Sixty-fourth session

PROPOSAL OF ADDITION TO ATP HANDBOOK

Annex 1, Appendix 2

Transmitted by the Russian Federation

Рис. 1

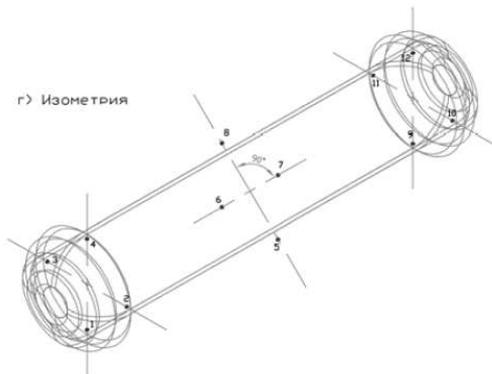
Comment to paragraph 21 a):

The location of temperature measurement devices inside and outside of one-compartment tanks is illustrated in fig. 1 (inside the tank) and fig. 2 (outside the tank).

Рис. 3

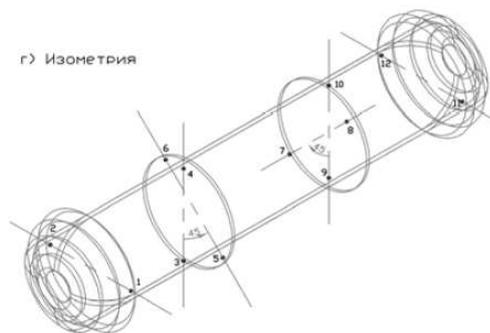
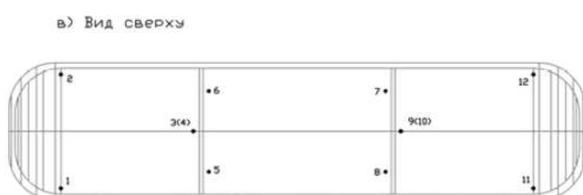
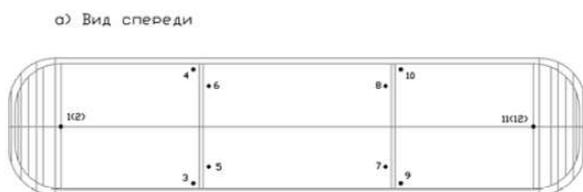
Comment to paragraph 21 b):

The location of temperature measurement devices inside and outside of multi-compartment tanks is illustrated in fig. 3 (inside the tanks) and fig. 4 (outside the tanks).
